UNITED STATES PATENT AND TRADEMARK OFFICE

APPLICATION NO.	FILING DATE	FIRST NAMED INVENTOR	ATTORNEY DOCKET NO.	CONFIRMATION NO.
10/802,899	03/16/2004	Shinichi Yamada	13869.28US01	4637

Office Action Summary	Application No. 10/802,899	Applicant(s) YAMADA, SHINICHI	
	Examiner Lan Nguyen	Art Unit 3683

DETAILED ACTION

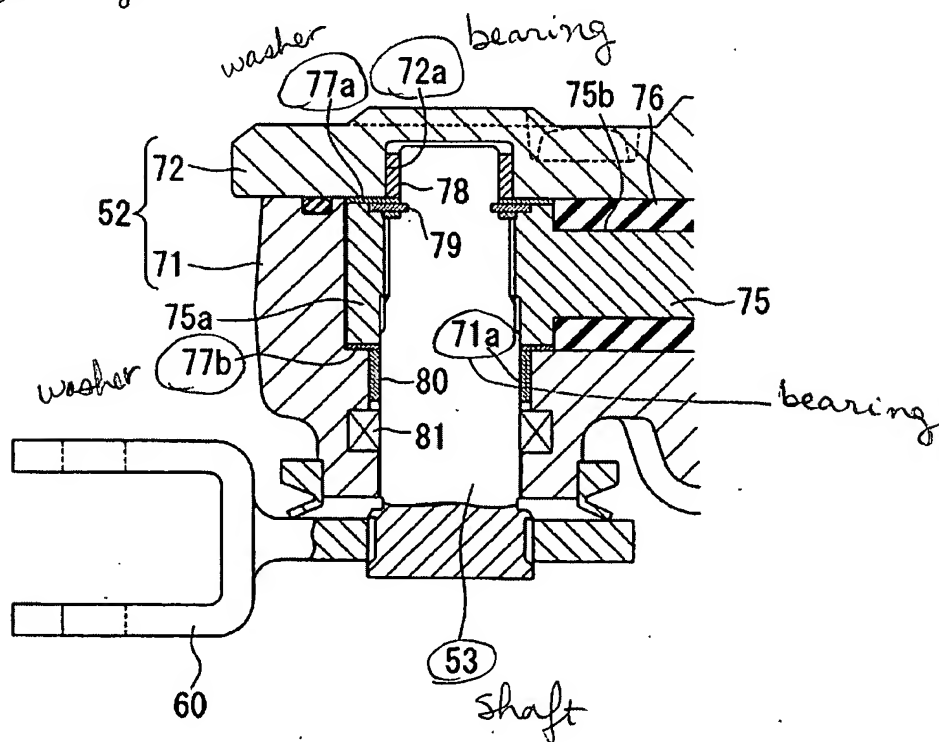
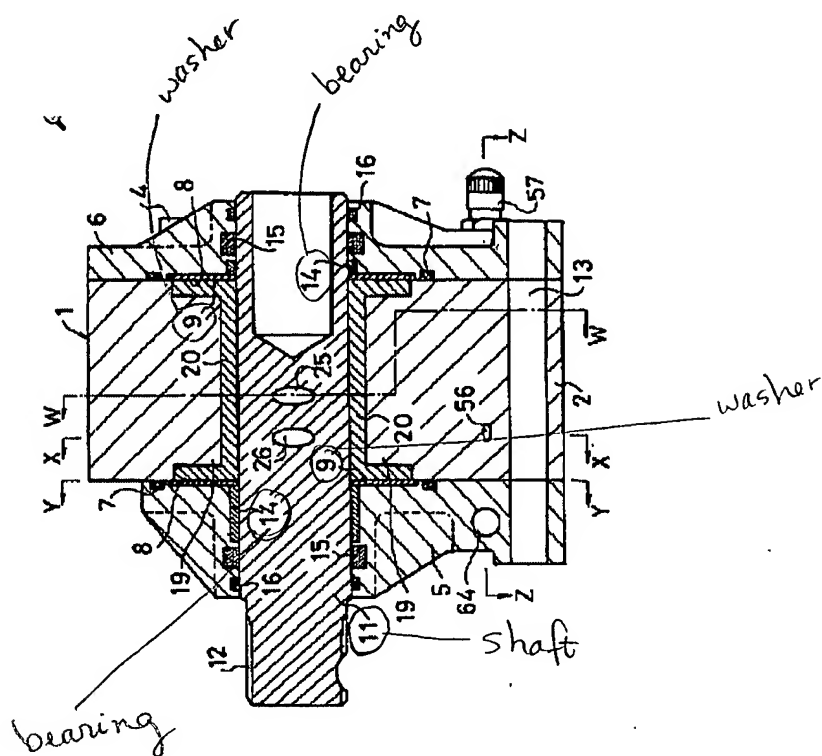
3. Applicant's arguments with respect to the claims have been considered but are found to be non-persuasive. Applicant argues that Yamamoto's washers 9, 9 are not provided on said base part and therefore do not provide a fluid tight seal on the base

part to divide a shaft bearing from the two chambers in a fluid tight manner as required by claim 1. Figure 7 of Yamamoto is reproduced and marked below in comparison to Applicant's figure 14. The arrangements of the two are similar as shown. The rejection is therefore deemed proper and is repeated above.
